# UNITED STATES PATENT AND TRADEMARK OFFICE

APPLICATION NO.	FILING DATE	FIRST NAMED INVENTOR	ATTORNEY DOCKET NO.	CONFIRMATION NO.
10/798,480	03/12/2004	Takayuki Ishii	Q80462	6262
23373	7590	08/18/2005	EXAMINER	
SUGHRUE MION, PLLC 2100 PENNSYLVANIA AVENUE, N.W. SUITE 800 WASHINGTON, DC 20037			COLILLA, DANIEL JAMES	
			ART UNIT	PAPER NUMBER
			2854

## Office Action Summary

## **DETAILED ACTION**

FIG. 1

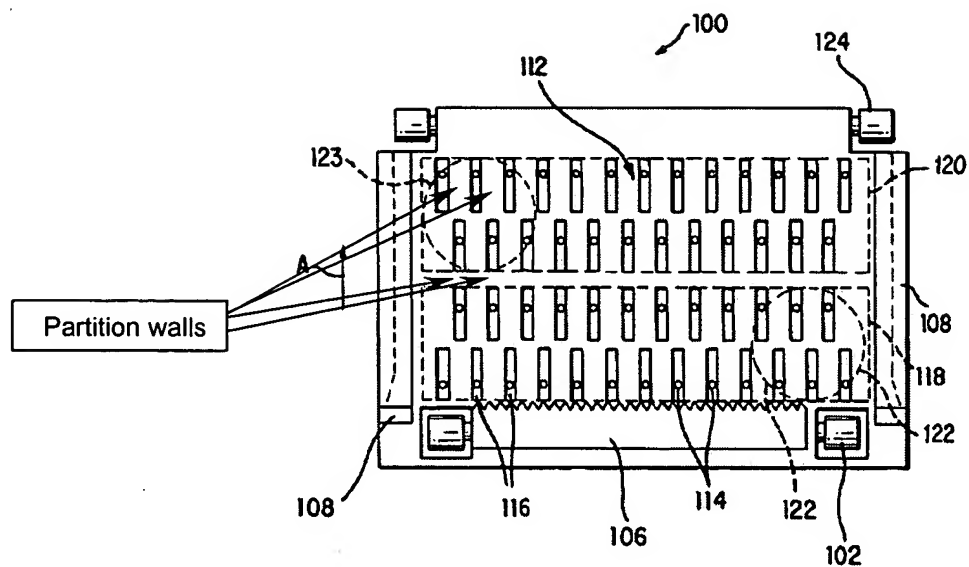
With respect to claim 2, each of the sucking chambers 116 includes a concave portion formed in the transportation surface 112 as shown in Figure 2 of Teumer, and the sucking chambers 116 are mutually partitioned by partition walls as shown below in the Figures taken from Figures 1 and 2 of Teumer:

With respect to claim 3, referring to the above Figure taken from Figure 1 of Teumer, the upper two arrows point to partition walls formed in the main scanning direction the lowest air points to walls formed in the subscanning direction.

With respect to claim 6, as shown below (Figure taken from Figure 1 of Teumer), the width of the top of the partition wall is smaller than a length of the sucking chamber 116.

FIG. 2

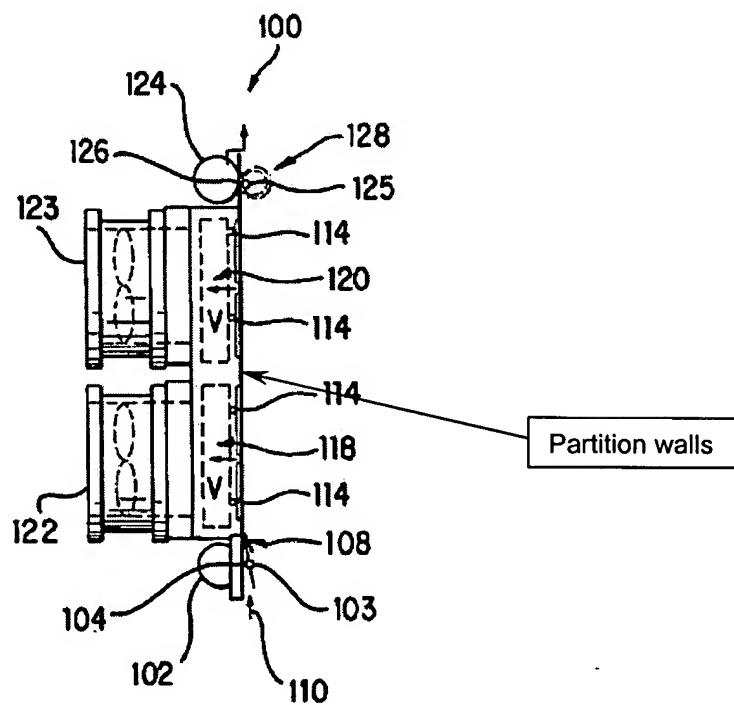
With respect to claim 4, each of the sucking chambers 116 has a sucking surface formed by an almost rectangular concave portion. It is noted that no manufacturing process will ever achieve a perfect rectangle and therefore the sucking chamber 116 disclosed by Teumer can be considered "almost" rectangular.

【図13】

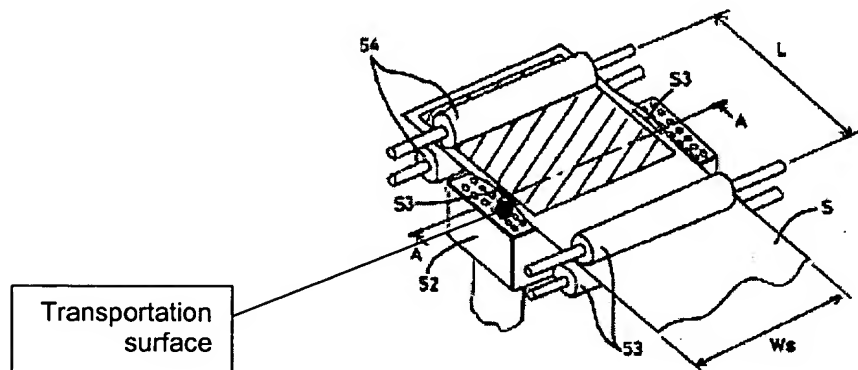
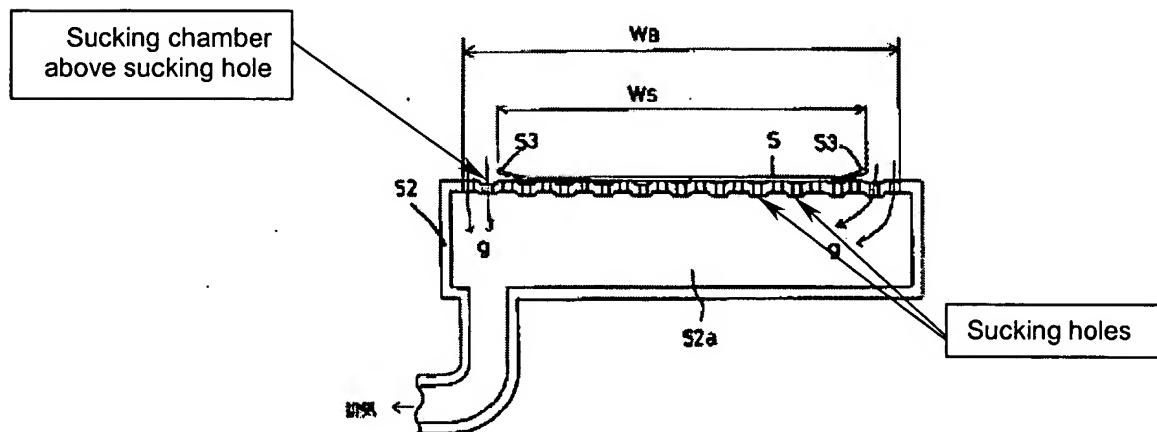
With respect to claims 1 and 10, Nomura discloses a fixed material transportation apparatus including a sucking unit which includes a fixed material transportation surface with a plurality of sucking holes, a decompression chamber 52a in communication with the sucking holes sucking device 19 (see Figure 11 of Nomura) for sucking air out of the decompression chamber 52a as shown in Figures 13 and 14 of Nomura and shown below in the Figures taken

from Figures 13 and 14 of Nomura. Further disclosed is a delivering device 53 (Figure 13 of Nomura) for feeding a material onto the transportation surface from an upstream side of the sucking unit to a downstream side. Figure 14 of Nomura et al. shows that each of the sucking holes is a through hole section communicating with the decompression chamber 52a and also includes a sucking chamber having a larger area of a sucking surface opposed to the material than a sectional area of the through holes section as shown in Figure 14 of Nomura.

With respect to claim 5, as shown above and in Figures 13-14 of Nomura, the sucking chamber has a sucking surface formed by an almost circular concave portion.
